SUBJECT: Submits info in response to NRC Question 410.10 re handling of light loads.

Re: St. Lucie Unit #2
Docket No. 50-389
Handling of Light Loads

St. Lucie Unit 2
Response to NRC Question 410.10
Light Loads

Figure 1

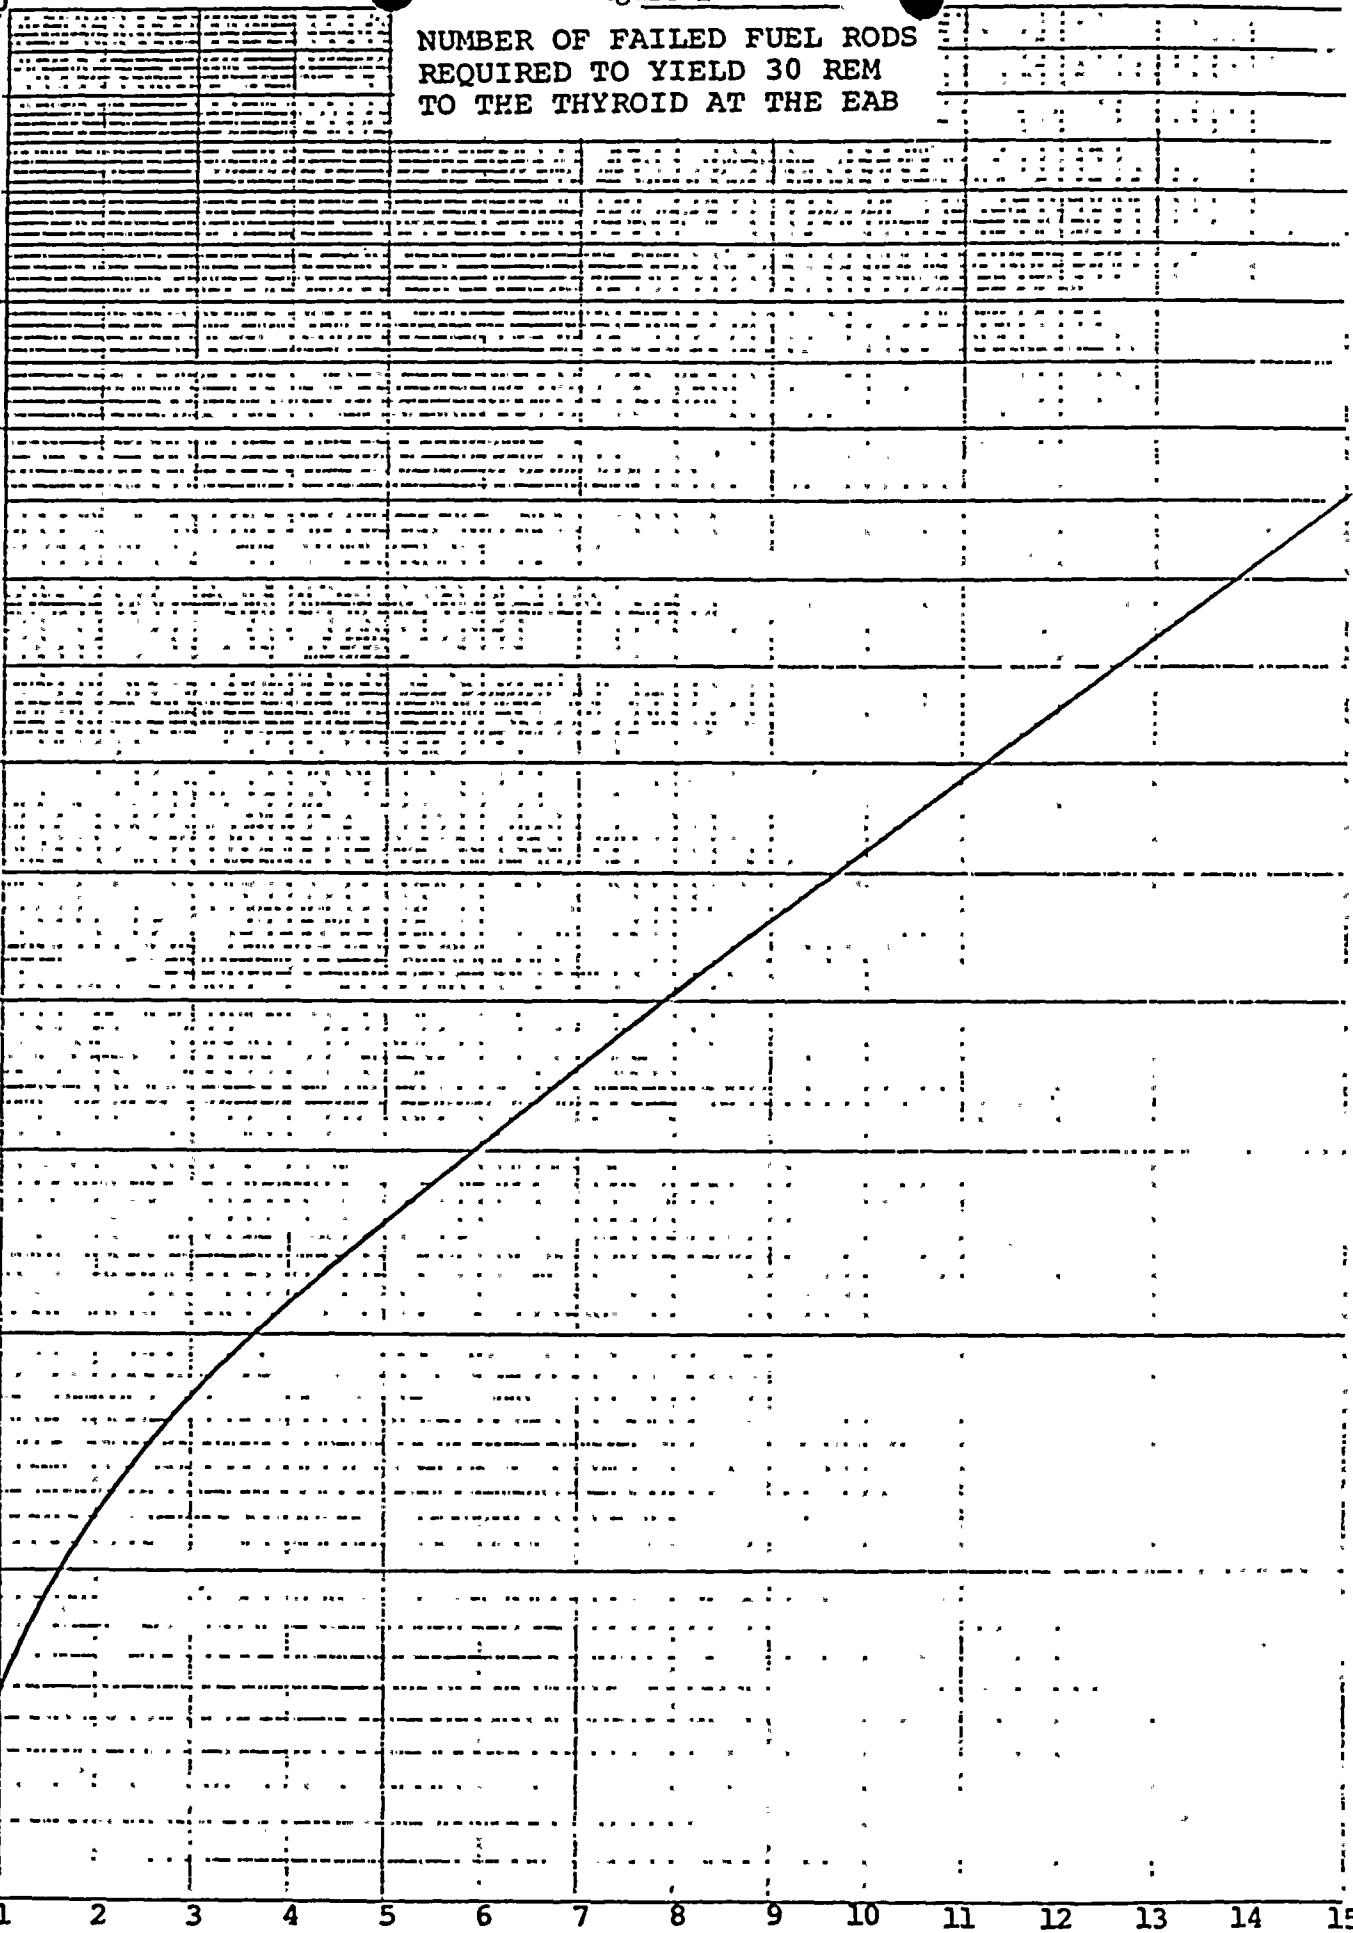
Question 410.10:

Describe, discuss and verify that the maximum potential kinetic energy contained in all objects of less weight than a spent fuel assembly which will be handled over spent fuel will not exceed the effects of the fuel handling accident in section 15.7.4 of the FSAR.

Rather than embarking on a very lengthy and state-of-the-art calculation to assess the precise damage that might be caused by dropped light loads, a simplified calculation was performed that indicated the number of fuel pins that could be damaged and not cause the site boundary dose to exceed a small part of 10 CFR 100 limits. The number of pins to cause site limits to be reached is dependent on the decay time allowed prior to release. The results of this calculation can be shown in Figure 1. As indicated on the figure, it will take only 6 days of decay to allow a release from one entire assembly without exceeding a small fraction of site limits. The time of decay is quite significant to this light loads concern. First, available gas curie content per pin decreases with time; i.e., the fission gas decay. Second, the minimum time that must pass before the fuel in the reactor is exposed to potential drop damage is several days. To date, the reactor vessel head and upper

guide structure has not been removed in less than 10 days; and this corresponds to decay time of sufficient duration to maintain site boundary limits even if 360 pins are damaged. As can be seen from these values, this corresponds to significant damage to 1.41 fuel assemblies. Therefore, from a qualitative standpoint, it is apparent that a dropped light load would need to cause considerable damage before any site boundary limits are exceeded.
